SUBJECT: JOSEPH M. FARLEY NUCLEAR PLANT, UNITS 1 AND 2 – FLOOD HAZARD MITIGATION STRATEGIES ASSESSMENT (CAC NOS. MF7924 AND MF7925)

STAFF ASSESSMENT BY THE OFFICE OF NUCLEAR REACTOR REGULATION

JOSEPH M. FARLEY NUCLEAR PLANT, UNITS 1 AND 2,

RECOMMENDATION 2.1- FLOODING CAC NOS. MF7924 AND MF7925

Figure 3.2.0-1. Site Map with Maximum LIP Flooding Depths, taken from the Farley MSA letter

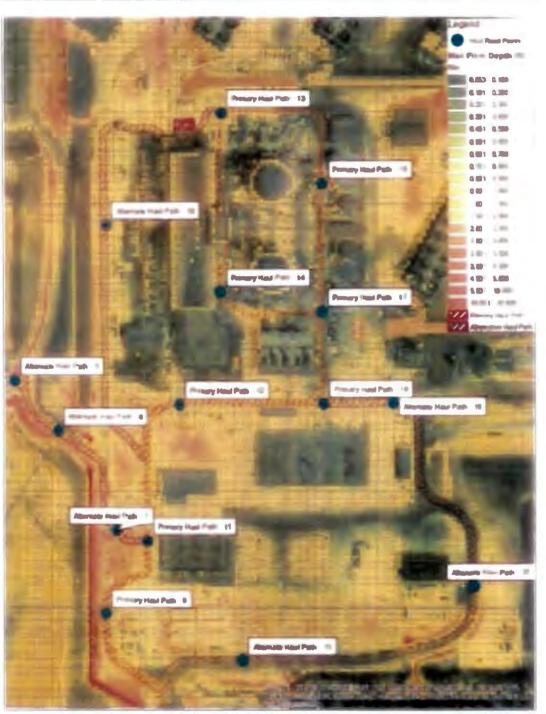
The licensee provided the maximum flood elevations at 18 selected monitoring locations near safety-related doors and at major haul pathways. Figure 3.2.0-1 displays the spatial distribution of the maximum flood elevations within the model area. Table 3.2.0-2 provides the maximum flood elevations for various locations.

In summary, the NRC reviewed the licensee-provided LIP FLO-2D model input and output files and confirmed the maximum flood elevations reported in the MSA letter. The staff performed a confirmatory run of the licensee-provided model and found no numerical instability in its solution, or any water budget errors. Therefore, and based on the review discussed above, NRC staff conclude the licensee's updated LIP modeling results are acceptable for use in the MSA.
